11758U-01

S E R V I C E N O T E

HP 11758U Digital Radio Test System

DATE: 12 August 1993

11757B-02 Modification Diagram

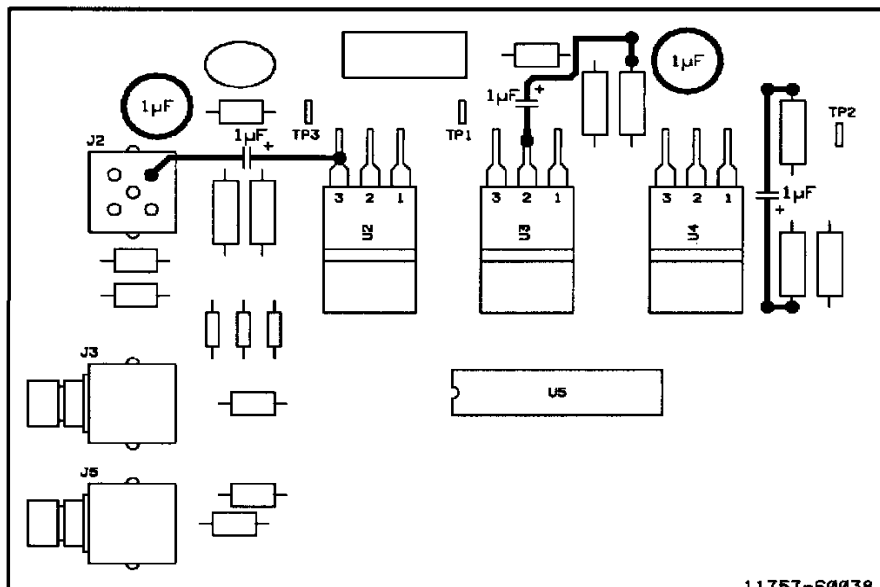
Some spurs 50KHz - 300KHz offset from the carrier, greater than the -67dBc specification for the RF source were observed on a few production units (11758). The problem was isolated to the EEPROM/Counter Board, both the current (11757-60056) and older (11757-60038) assemblies, on the U2, U3, and U4 regulators. The fix was to add 1uF capacitors to the input and output of the regulators as described in the regulator's application notes. This makes the regulators optimally stable and eliminates oscillations which were causing the spurs on the RF source's signal. The older board (11757-60038) can be retrofitted with a field installable modification (described in this service note) rather than replacing the board with its direct replacement, the Counter/EPROM Upgrade Kit (11757-60059). This eliminates the need to scrap the old board and order both the new board and new firmware contained in the kit. The updated older board (11757-60038) will become 11757-60061 after the fix is implemented. Similarly, the 11757-60056 can be modified and would become 11757-60060.

1. Place board on a bench equipped with an ESD mat. Make sure person performing this modification is grounded also. Observe all normal ESD precautions while this procedure is being followed.
2. Make sure that all exposed capacitor leads are covered with the insulating tubing to prevent contact with other points on the board.
3. Attach the non-polarized lead from a 1uF capacitor (0180-4129) to pin 2 of U3 and solder it.

4. Unsolder the lead of R7 closest to the edge of the pc board and solder a post connector into the hole. Re-attach R7 to the post as well as the polarized (plus) lead of the 1uF capacitor that was soldered to U3 pin 2.

5. Unsolder opposing leads of R30 and R10 (see diagram) and solder post connectors into both locations. Re-attach respective leads for R30 and R10 as well as leads for a 1uF electrolytic capacitor (0180-4129). Make sure polarized (plus) end of the capacitor goes to the R30 lead.

6. Attach the polarized (plus) lead of a 1uF electrolytic capacitor (0180-4129) to pin 3 of U2 and solder it. Remove the solder from the J2 ground hole indicated on the diagram, insert the remaining capacitor lead and solder.

7. Remove both capacitors C11 and C9 and replace with 1uF capacitors (0180-3771). Note that since these are three-lead items, it does not matter which way the capacitors are oriented.

The new board (11757-60060) contains the complete solution for the spur problem described above. However, the older boards (11757-60038 and 11757-60056) both have the potential to exhibit this problem. Repairs or replacements should follow the strategy as outlined in the matrix below:

8. Type the appropriate board number (according to the above matrix) on the label and apply over the existing board number.
9. This completes the modification procedure. After board is reinstalled in the instrument, please repeat spur tests to confirm that spurs found in the 50KHz - 300KHz carrier offset region have been eliminated.
